Camden Town Conservation Area Advisory Committee

Comments on proposed alterations to 3a, Camden Road

Planning Application ref. 2019/3693/P

Original gables at no 3a (left) and no. 5 (right_

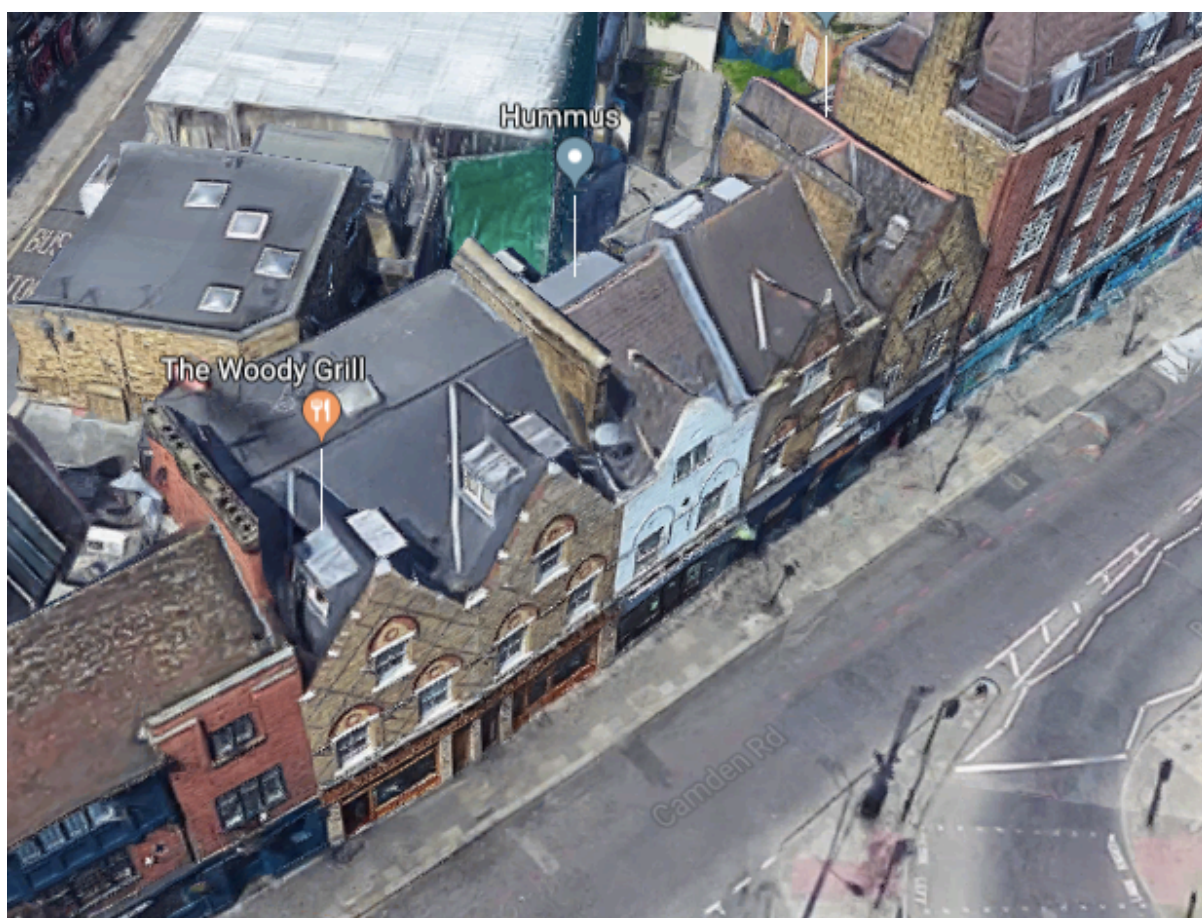
Again it is obvious that the front elevation of no. 5 is original. It is the same design as that of no. 3a, although the latter is damaged and obscured with white paint. The details of nos. 3a and 5 differ from the pair at nos. 1a and 3.

The differences between the two pairs are at second floor and roof levels:

- 1a and 3 have larger gables
- 3a and 5 have wider window openings at 2nd floor level (although the windows are modern, the original stone lintels and cills remain)
- the arches above the 2nd floor windows have rounded heads, not pointed, and the brickwork is flush, not recessed.

The existing front elevation of no. 3a does not show this detail correctly. The original detail is still present and should be drawn in the same way as no. 5, including the stone lintel and cill.

The roof should be retained as existing. The front gable should be repaired to match that no. 5. Any approval should be conditional on the careful removal of the existing paint and conservation of the brickwork.
